Updates and changes to be done to ALL BA-660's

## Z:\LIMITER\Updates and Changes\UPDATES\_09-6-2015.txt

## UPDATES\_12-1-2012.txt

Q40 Fix

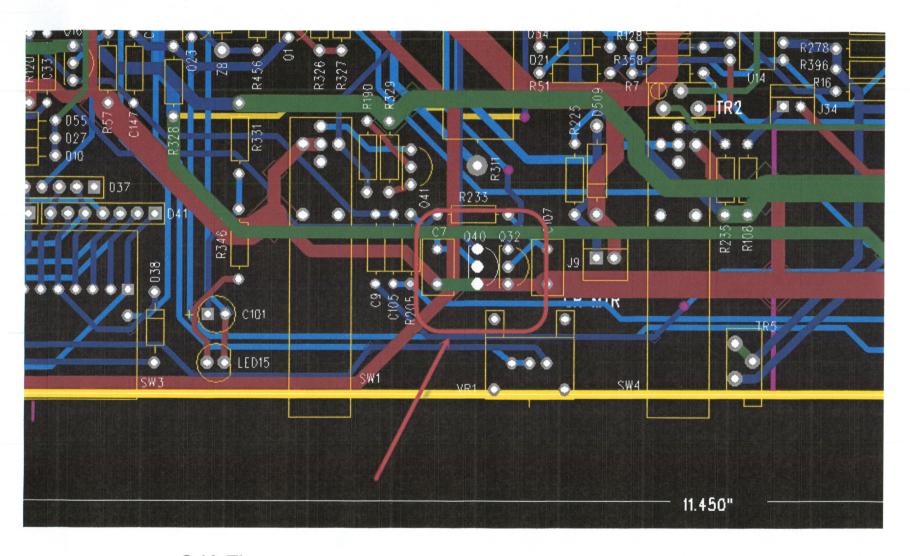
1. Reverse Q40 Emitter and Collector, Modify schematic as well Transistor reversed causing bypass pops

Change Q40 from 2n5401 to MPSA77
